## Attachment 2: OEH Review of Impacts of Springvale Mine Extension Project (SSD 5594) on Upland Swamps

### Impacts on Newnes Plateau Shrub Swamps

Figure 1. Longwall mining impacts on groundwater levels within Kangaroo Ck Swamp (Red Line) compared to natural water level fluctuations in a reference swamp (Sunnyside Swamp; blue line), rainfall (vertical grey bars) and rainfall deficit (Black line). Source: DECCW 2010.

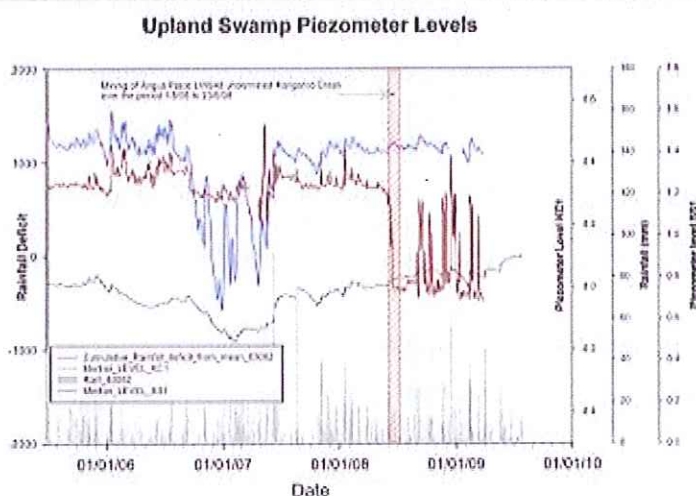
*The mine design consequence is that narrower panels (261 m void width) are proven to minimise impacts on sensitive surface features.*

This was not the case for LW940 (262m wide longwall) where the perched aquifer in Kangaroo Creek Swamp was lost (see Figure 1).

Figure 2. Longwall mining impacts on groundwater levels within Kangaroo Ck Pool KWH (Blue Line) compared to rainfall deficit (Black line - Bilpin BoM rainfall; Red Line - Lidsdale BoM rainfall; Pink Line – Newnes Plateau). Source: Adhikary and Wilkins 2013 and OEH based on BoM rainfall data.

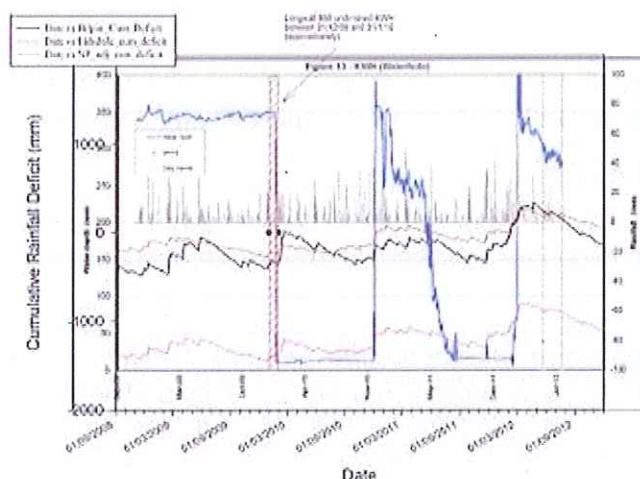
*A letter by Centennial (2008) to the then Department of Primary Industries stated that "Following rainfall during the last week, surface flow has resumed over the Longwall 940 surface area of Kangaroo Creek and water level in the bore has returned to within 50 mm of the previous level", which indicates that these impacts appear to be transient.*

OEI considers this statement to be misleading since a longer-term plot of levels within KWH (Figure 2) clearly indicate impacts are not "transient" but sustained (with rainfall related responses and

significantly different pool level recession rates pre and post undermining; see also Connell Wagner reports/comments regarding pool KWH cited above).
